Exeter City Council

Water Lane Design Code

RE: LIVEABLE WATER LANE SUPPLEMENTRY PLANNING DOCUMENT – TRANSPORT & MOBILITY TECHNICAL NOTE

Insert 2.3 – Extract WLDMC Access Drawing plus SLR annotations

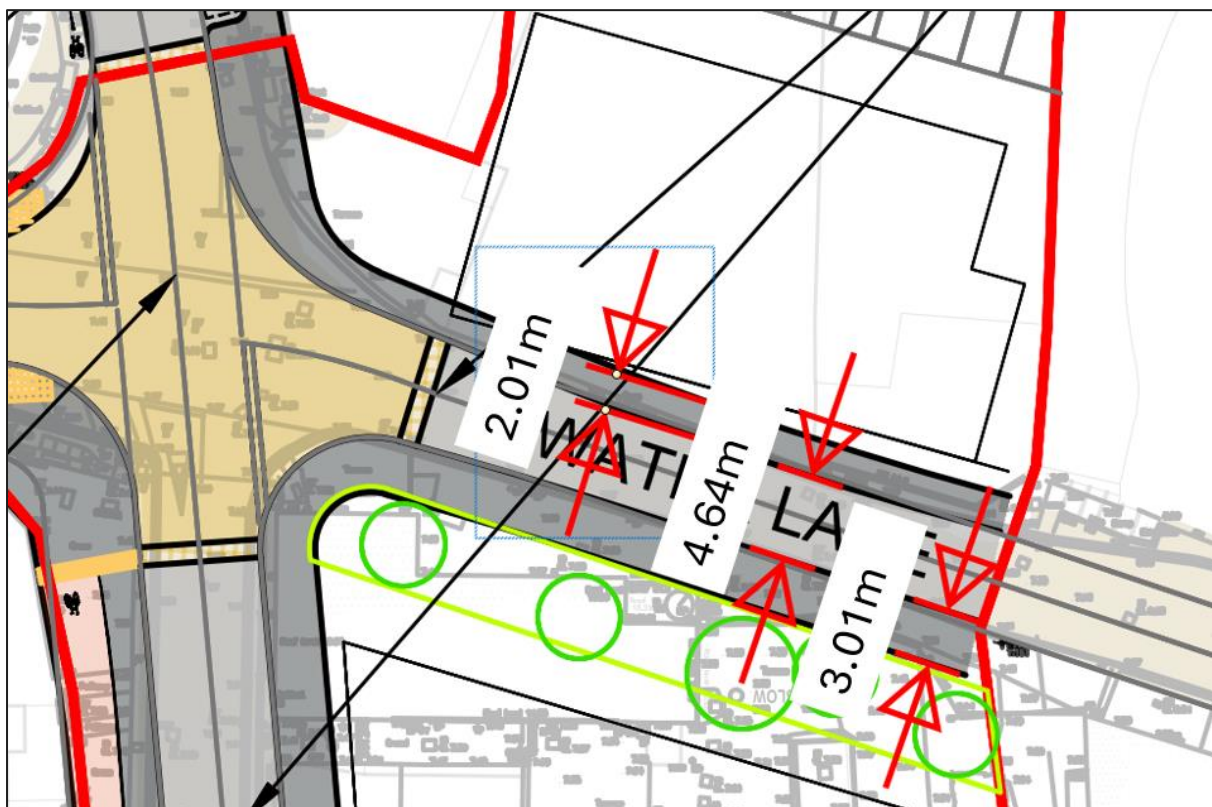
- 2.13 Noting that the WLDMC are pursuing an active planning application with matters of access to be agreed, a review has been undertaken of the proposed access arrangement set out on Drawing No. 332310057-5503-001, submitted alongside the application. This specifically relates to the section of Water Lane from its junction with Tan Lane running east to the boundary with Vulcan Works and ECC land, establishing whether the design as proposed impacts on access opportunities for the Water Lane North development area, via Water Lane.
- 2.14 Measurements have been taken using the pdf file provided with the planning application, with approximate dimensions depicted in **Insert 2.3** below.

- 2.15 It is notable that the carriageway width appears to be inconsistent ranging from 4.8m in width to 5.0m, with a 3m shared footway cycleway along the southern side and a footway of 2m in width along the northern.
- 2.16 If Water Lane is to provide access for the Water Lane North development area (as depicted in Option 2b), the carriageway is not of a width to allow two service vehicles to pass one another, with the minimum criteria being 5.5m at slow speed. This is evident from the vehicle tracking submitted alongside the planning application which indicates that a large HGV and car would have difficulties passing one another along this length. Extracts of this tracking exercise are provided as **Insert 2.4** below.

- 2.17 The WLDMC's proposed shared pedestrian/cycle provision along Water Lane is currently limited due to the width of the carriageway. Whilst shared cycle/traffic use may be possible, space can be made for further segregation; there is sufficient land under the applicant's control to facilitate a segregated cycle link subject to agreement between landowners. This would be the authorities' preference.

- 2.18 The current width of the carriageway is such that the movement of vehicles into and out of Water Lane will remain restricted, which could present an issue in the short to medium term if public transport services are expected to use this route, alongside vehicles currently serving the Vulcan Works site.

- 2.19 Should access Option 2a be progressed, this section of Water Lane should be reviewed accordingly. With Option 3, assuming the removal of general traffic from Water Lane, including that from the Vulcan Works, the current access design could be workable, subject to further refinement during reserve matters stages which should seek to prioritise pedestrian/cycle routing and segregation where possible. Suggestions have been set out within the SPD.

- 2.20 Alongside these access options, the restricted nature of Water Lane is such that on-street parking should be prevented along its length to ensure available carriageway space is maximised. Appropriate measures should be set out in future proposals which could comprise a mixture of discrete off-street parking for essential car users and servicing requirements, with appropriate restrictions and enforcement.
